Bulletin type: **FIELD FIX CONDITIONAL**

Subject: **TS45 WC Vibration Sound  
Improvement**

Bulletin Number: **TS45-FC-2516**

Vehicle Model: **TS45**

**WC Area:** Double-sided SM and hard styrofoam were placed between the water tank and the main body, preventing the flexibility and eliminating the noise problem. (25 minute)

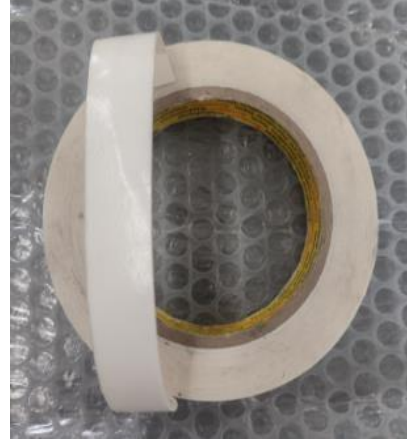
7- Insert the appropriate size insulation foam (self-adhesive or with double-sided tape) at two points between the closet cover and the waste tank, as shown in the pictures below.

**Maintenance Cover:** By applying single-sided black SM26 around the maintenance cover, the flexibility is prevented and the noise problem is eliminated. (5 minute)

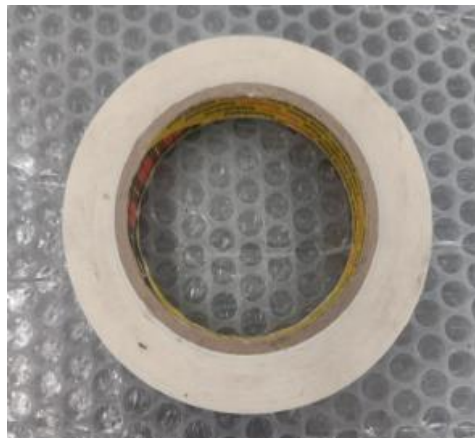
**Mica Glass Area:** Double-sided white SM tape is applied between the glass and its frame to eliminate flexibility and reduce noise. (10 minute)
